Memorandum

Project #: 14319.00

Re: 1114 Beacon Street Redevelopment
Response to Transportation Peer Review Comments
Memorandum by BSC Group, Inc., dated May 4, 2020

Turning Movement Diagram - TNC Vehicle
 The Beacon
 1114 Beacon Street
 Newton, Massachusetts

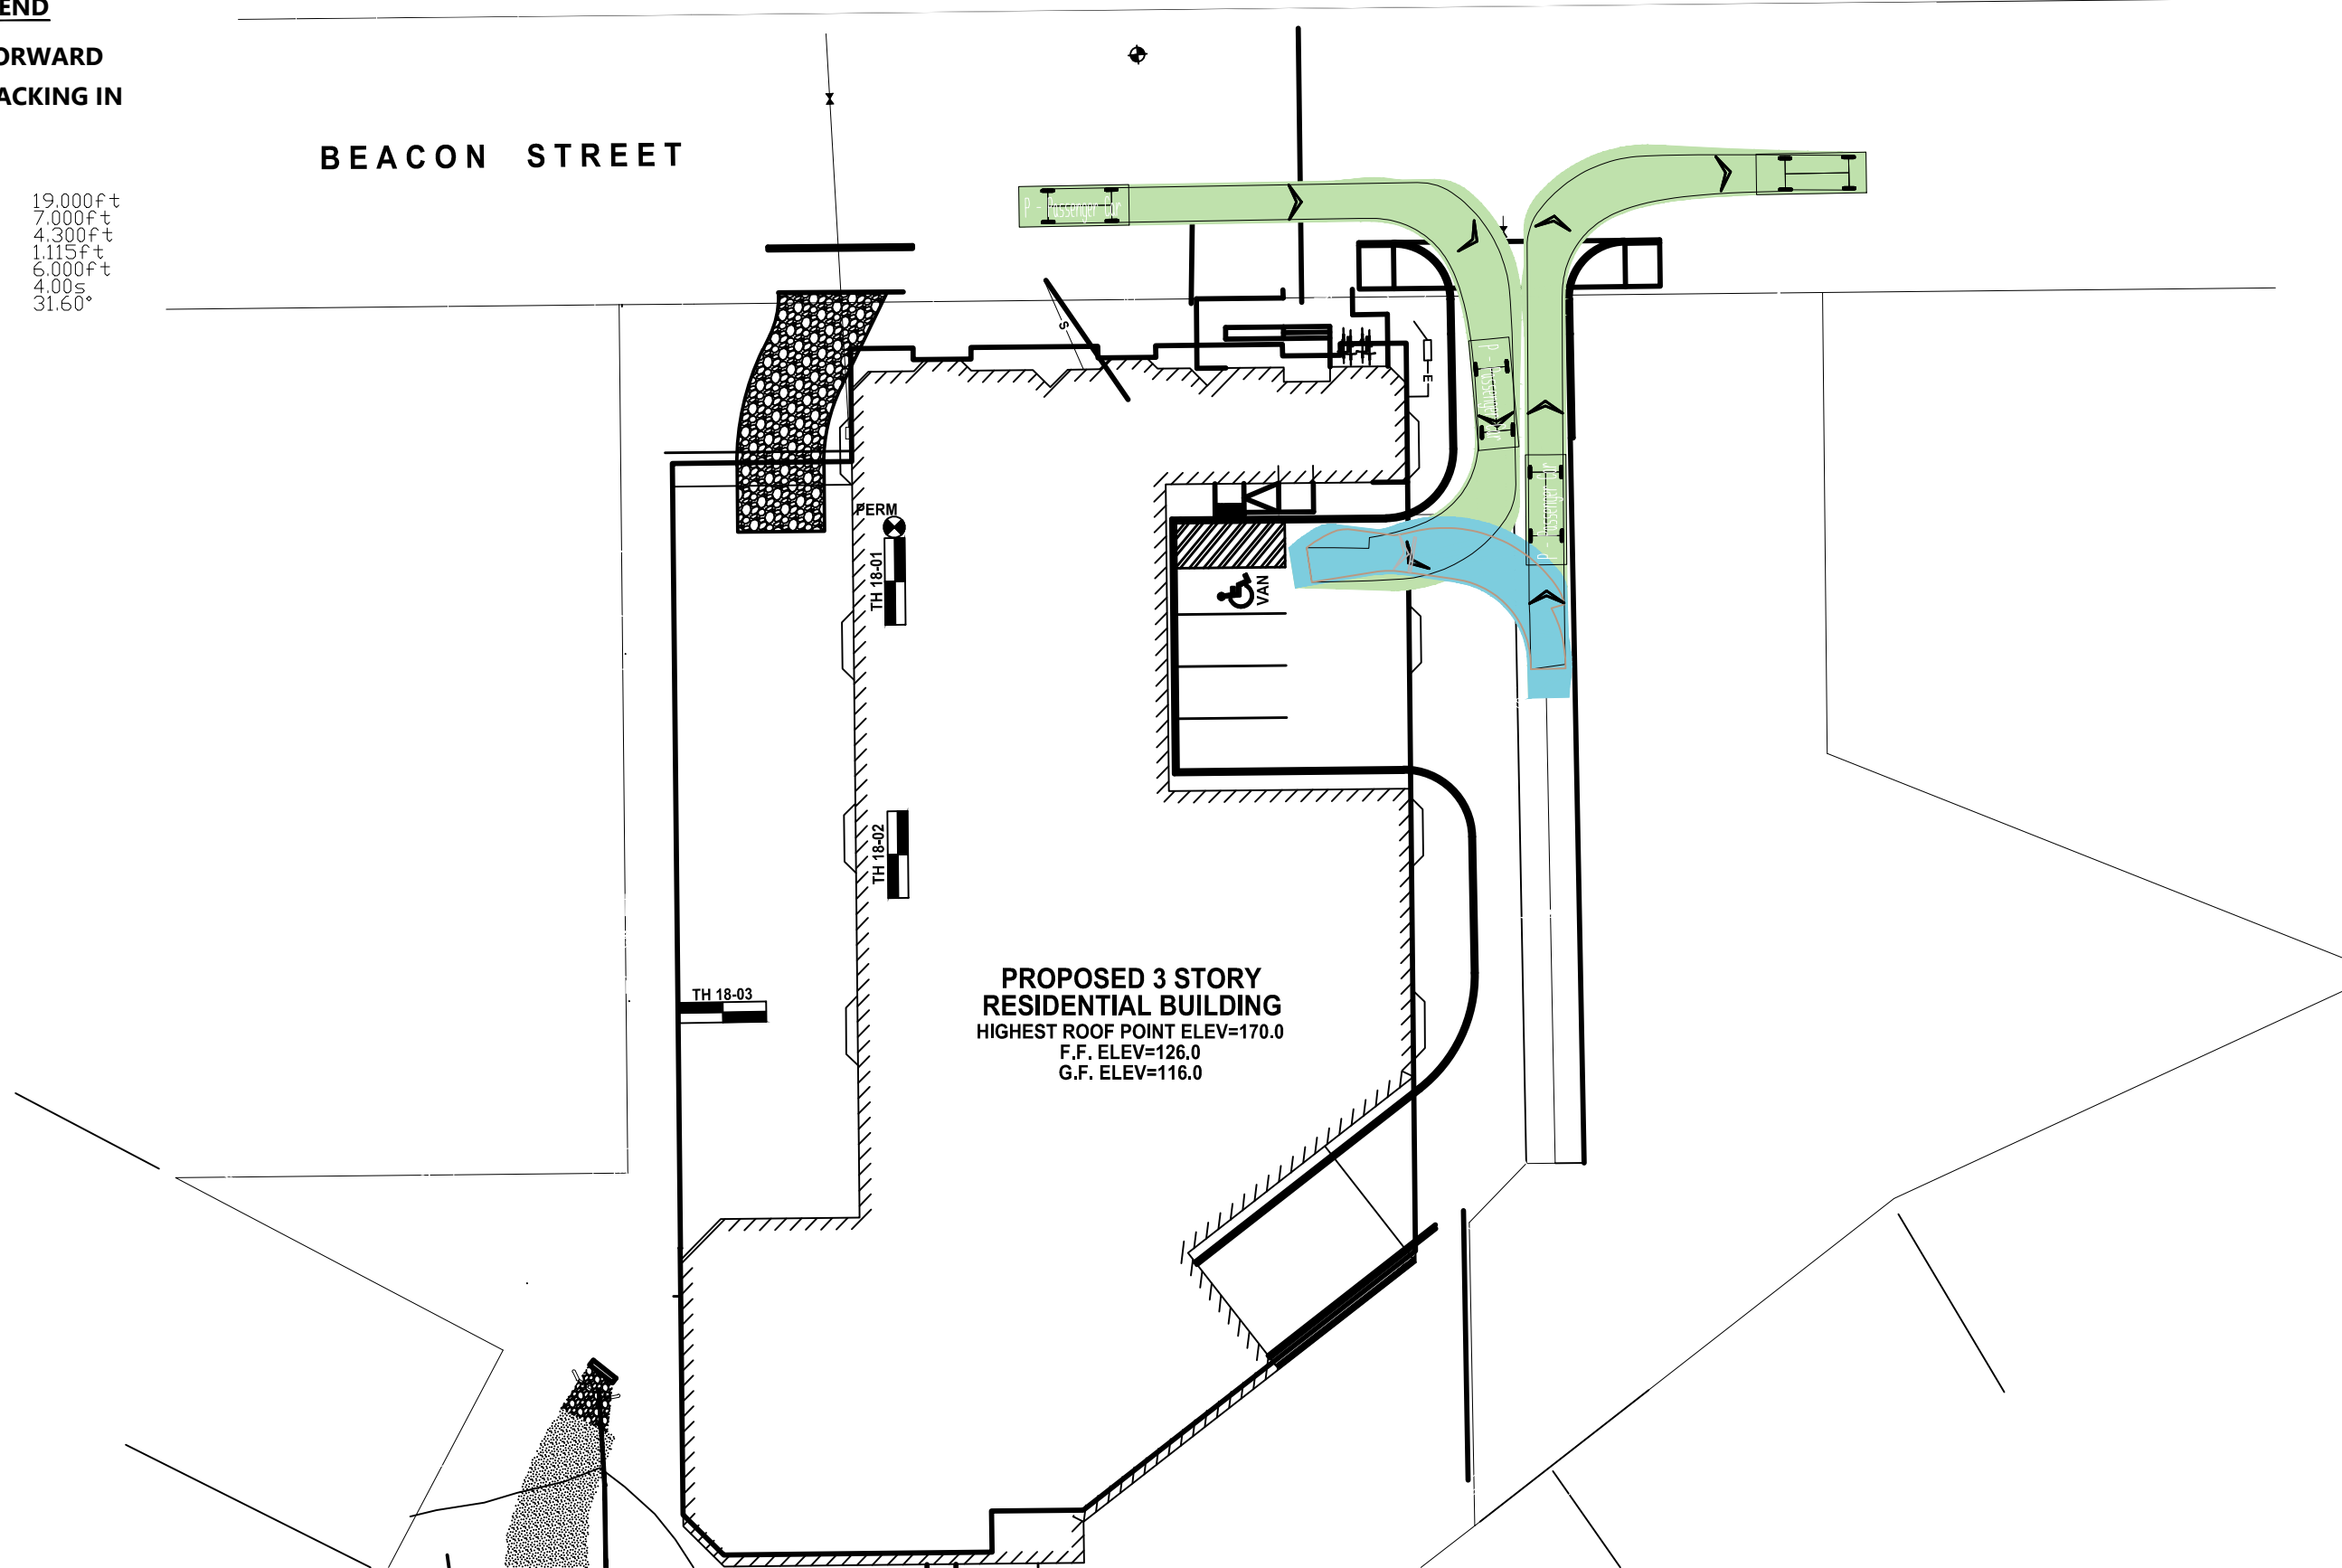
Comment 11: An evaluation of pick-up/drop-off, delivery, move-in/move-out activity, and trash pick-up was not provided in the TIAS. The Applicant should provide information related to these activities. The Applicant should provide updated vehicle turning maneuvers throughout the site based on the largest moving vehicle expected to serve the Project. The Applicant should also identify where pick-up/drop-off, deliveries, loading, move-in/move-out, and trash/recycling will occur on the site.

Response 11: It should be noted that access to the site has been substantially changed based on comments from the City of Newton Planning Department and the City appointed peer consultant. Specifically, the former plan had two access driveways. Planning and the peer reviewer requested that the two driveways be consolidated to a single driveway. Based on those comments, the Proponent has created a single access driveway for the site. While a single access driveway may be less efficient for the site, operations with certain protocols will work for this facility. Access and circulation for the various types of vehicles is described below. In addition, AUTO turn diagrams have been prepared for each type of vehicle and are included as an attachment.

- Drop-off and pick-up (Taxi's, Uber, etc.): A car would pull in the driveway and park along the curb at the Drop-off entrance. Alternatively, the car can pull into one of the visitor spaces if it is available. The car leaves the site by backing out into access aisle.

Revised Site Plan with Bike Rack

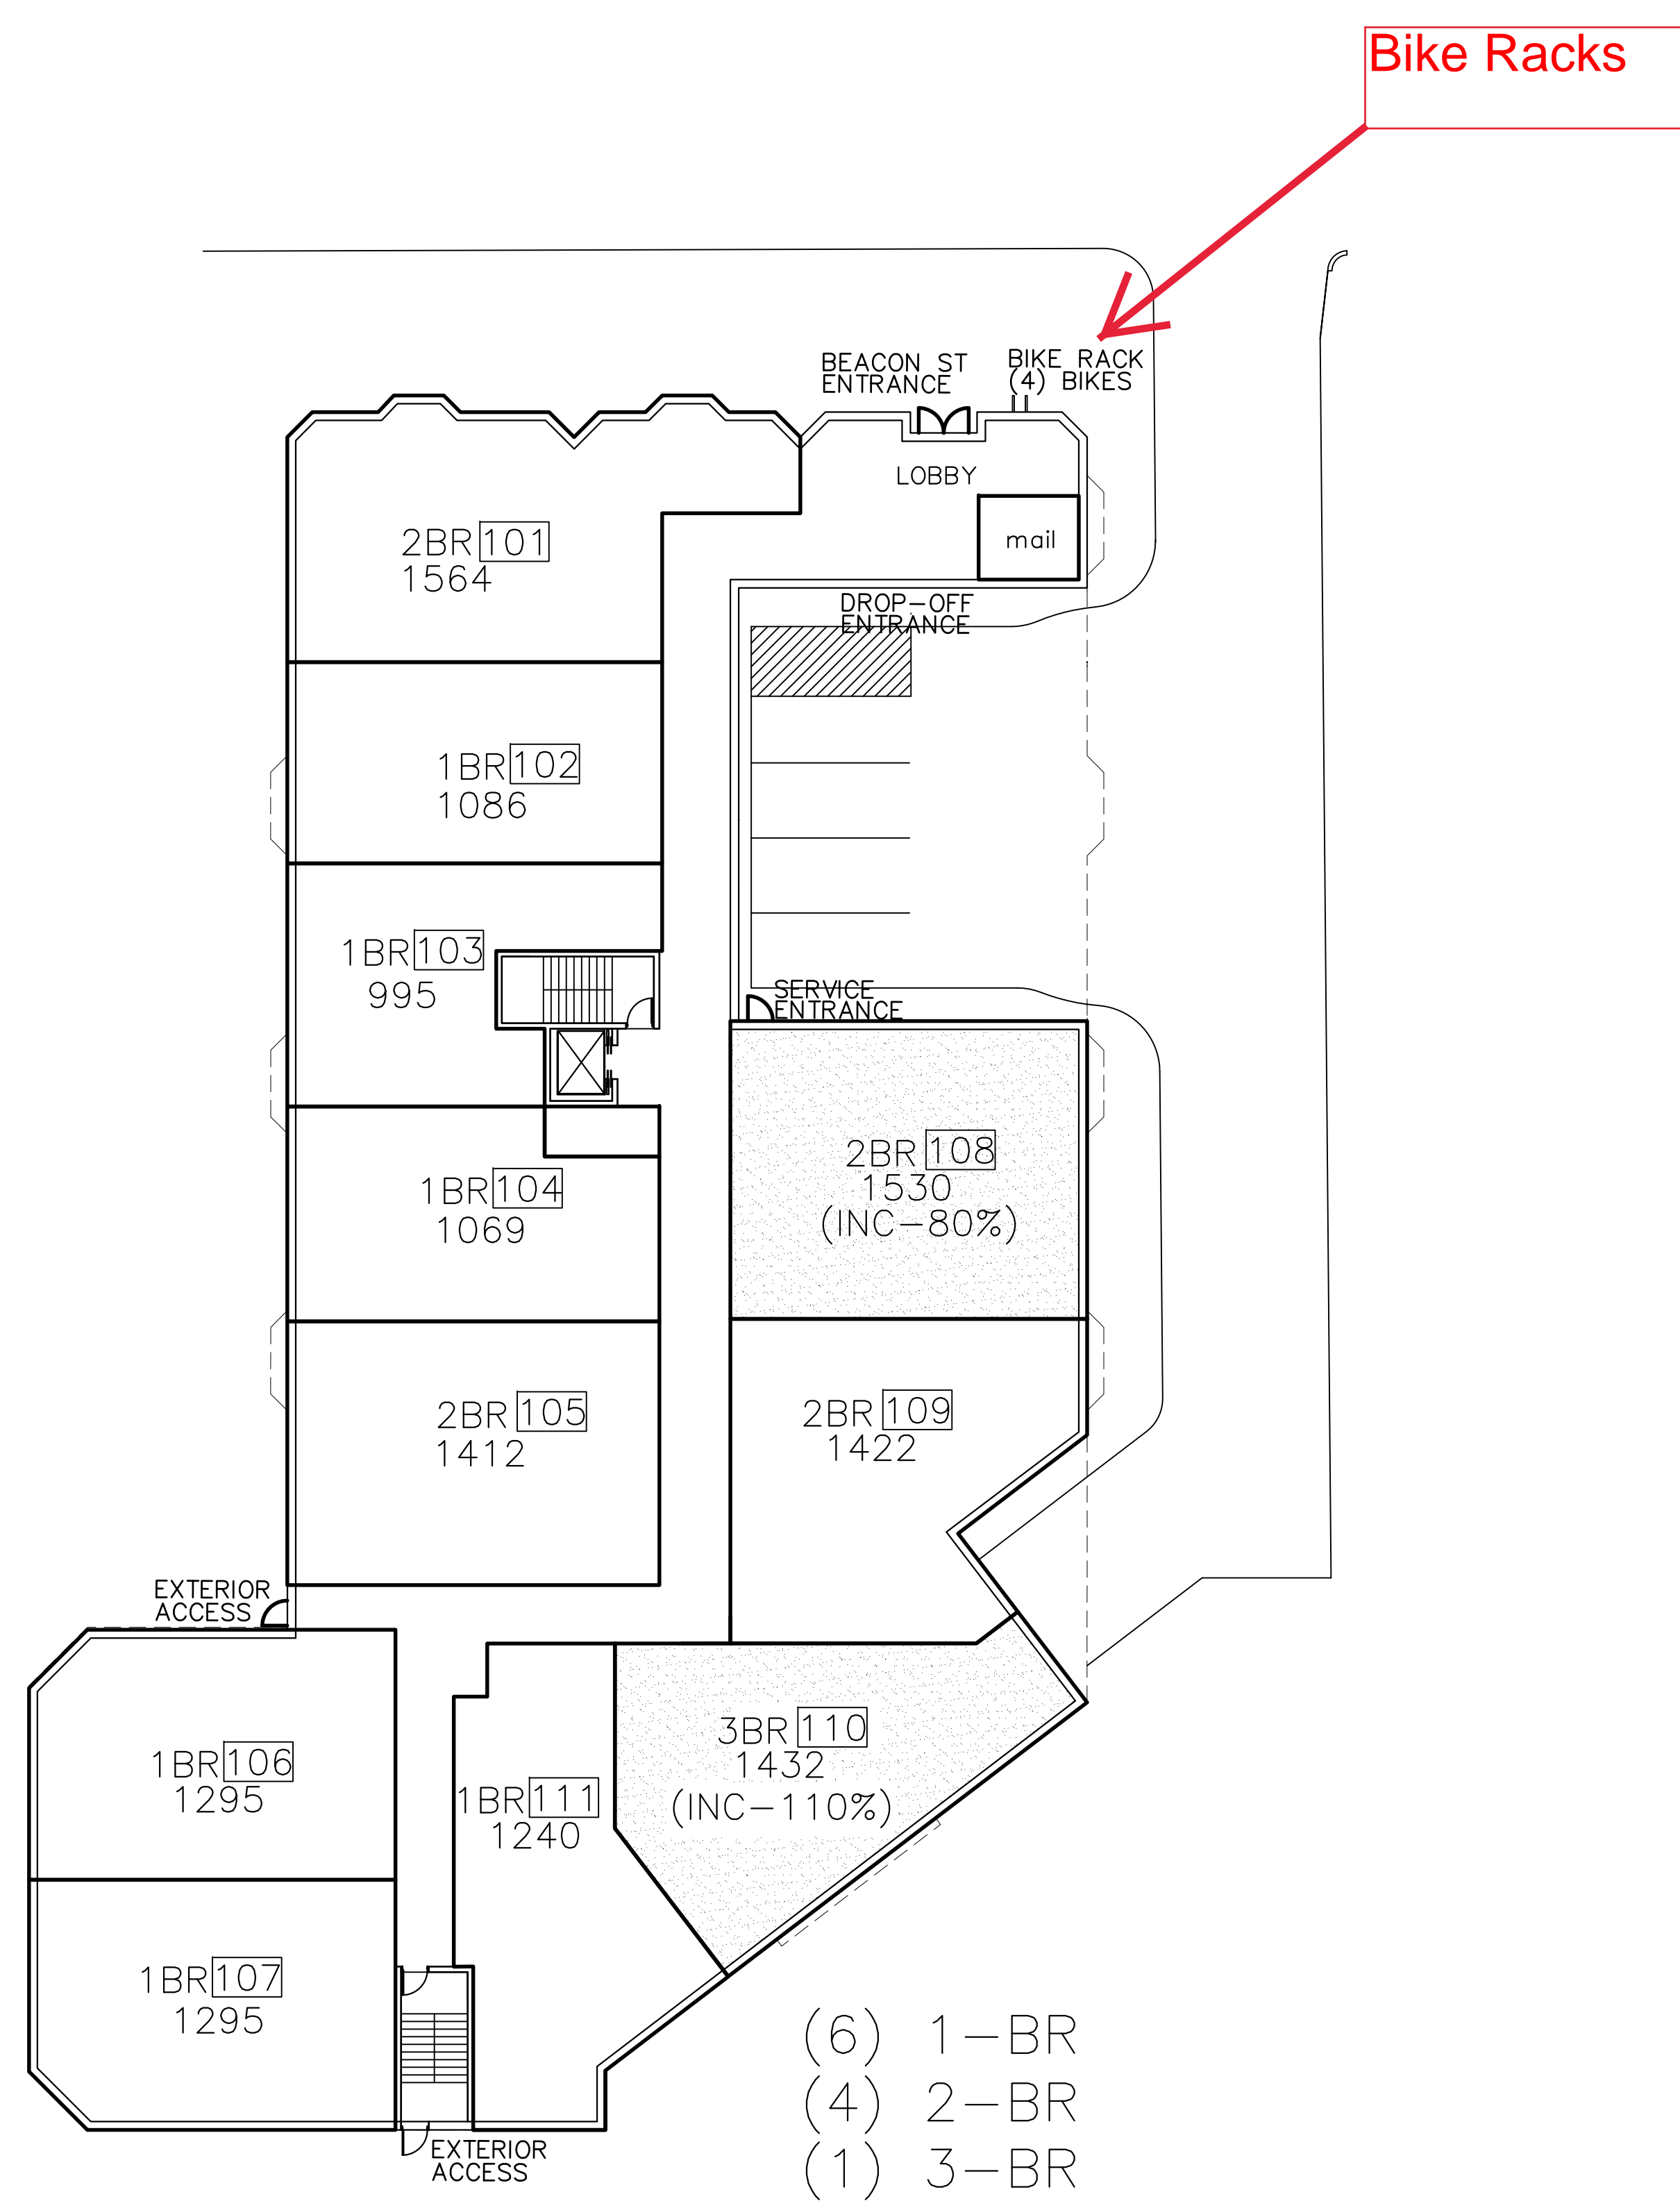
Comment 13: BSC recommends that the Applicant provide exterior bicycle racks for visitors.

Response 13: In response to this comment, two bicycle locking posts will be added (4 bicycle capacity) adjacent to the front door with added walkway pavement for this area. See the revised plan attached.
